Re: Approval of the Final Plat of Venwoods Estates 4th Addition, a proposed 6 lot residential subdivision in SW¹/₄ of the SE¹/₄ of Section 6 and NW¹/₄ of the NE¹/₄ of Section 7 all in Pleasant Valley Township.

STAFF REPORT

Request: Final Plat of Venwoods Estates 4th Addition

VENWOODS ESTATES FOURTH ADDITION

PROJECT: FINAL PLAT VENWOODS ESTATES 4th ADDITION BETTENDORF, IOWA

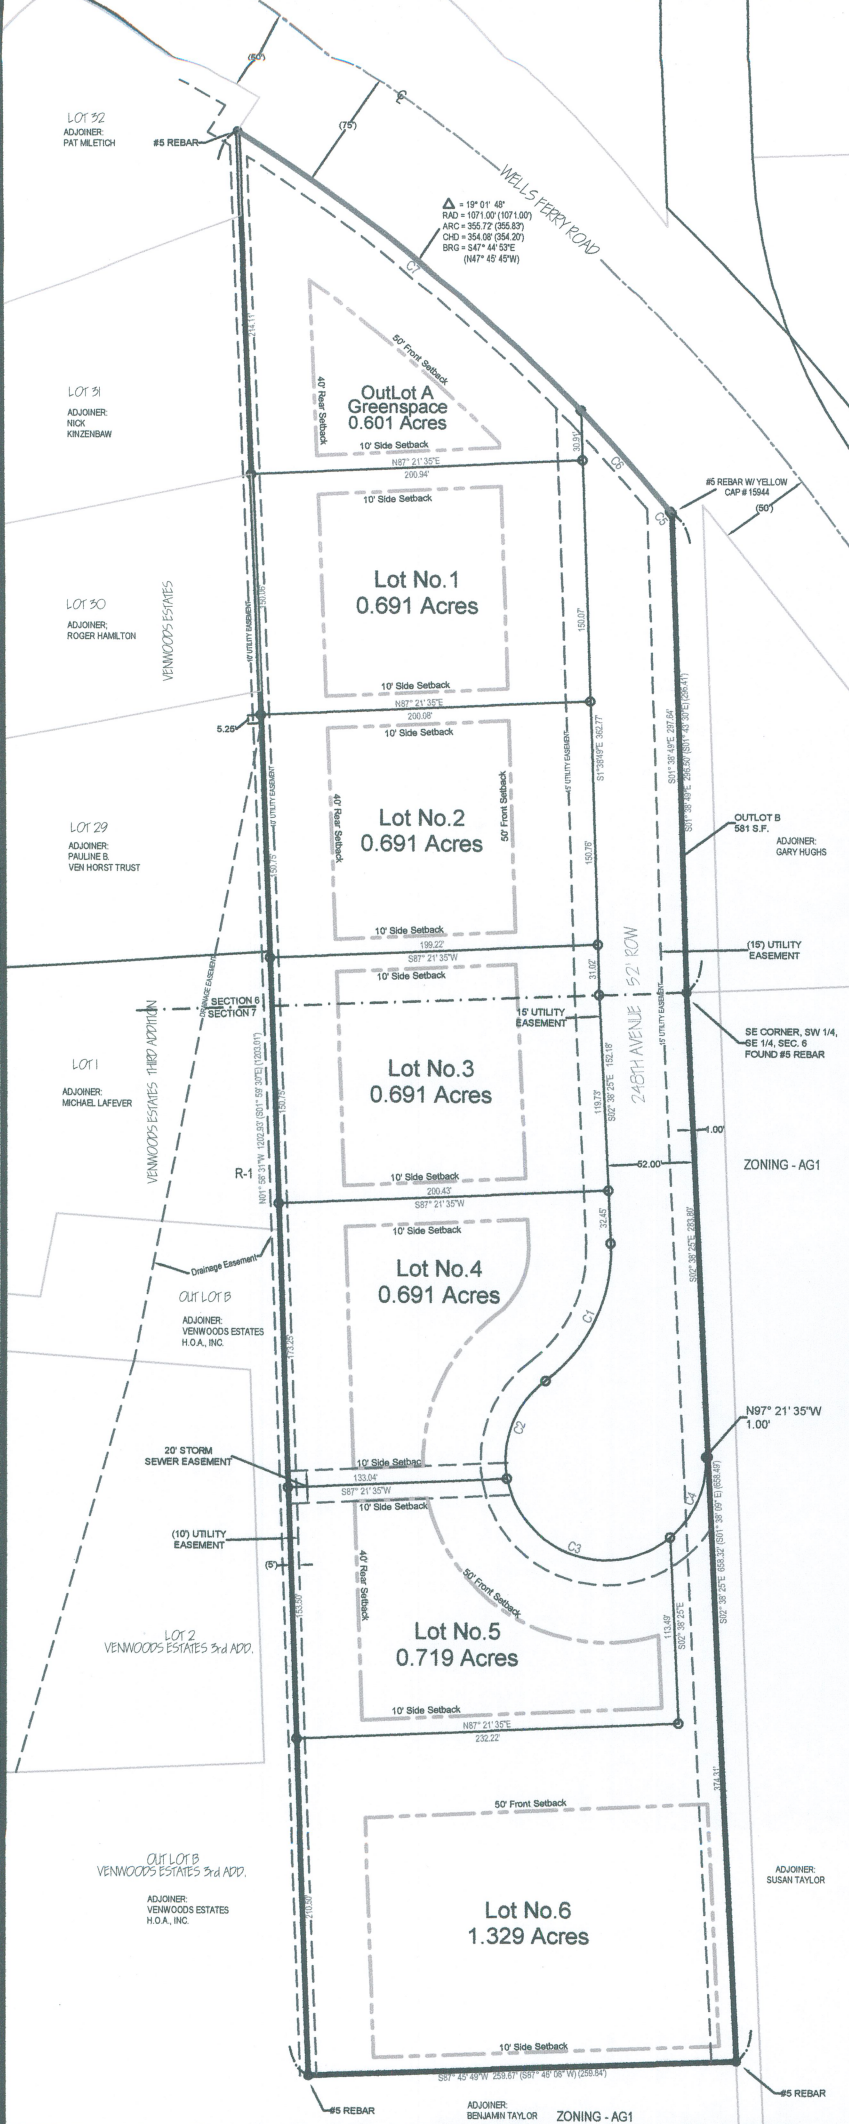
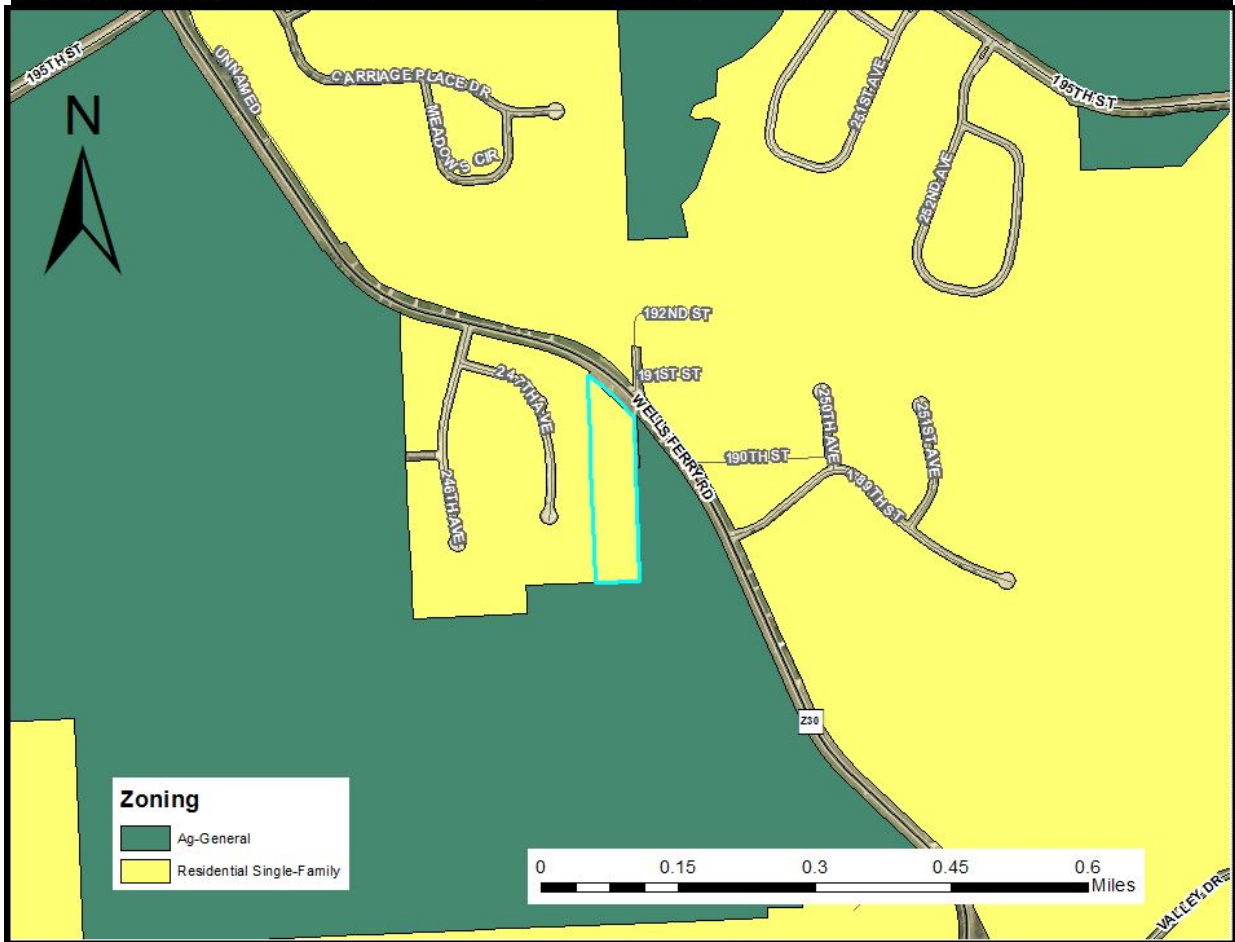
the Board of Supervisors after the subdivision plat is approved. The existing Venwoods Estates streets are maintained by the County. The County Engineer stated he would not recommend this cul de sac be accepted onto the County Secondary Road system and requested that the note on the plat stating 248th Street R.O.W. would be dedicated to Scott County be deleted prior to approval of the plat.

The County Engineer recommended that the note reading, “248th Street R.O.W. be dedicated to Scott County with the acceptance and recordation of this plat,” be removed prior to recording since he is recommending this street remain private, though he did review and approve the street construction plans.

1. The plat note reading, "248th Street R.O.W. be dedicated to Scott County with the acceptance and recordation of this plat," be removed prior to recording as recommended by the County Engineer; and
2. The subdivision infrastructure improvements be completed or a surety bond posted prior to Final Plat approval.

1. The plat note reading, "248th Street R.O.W. be dedicated to Scott County with the acceptance and recordation of this plat," be removed prior to recording as recommended by the County Engineer; and
2. The subdivision infrastructure improvements be completed or a surety bond posted prior to Final Plat approval.
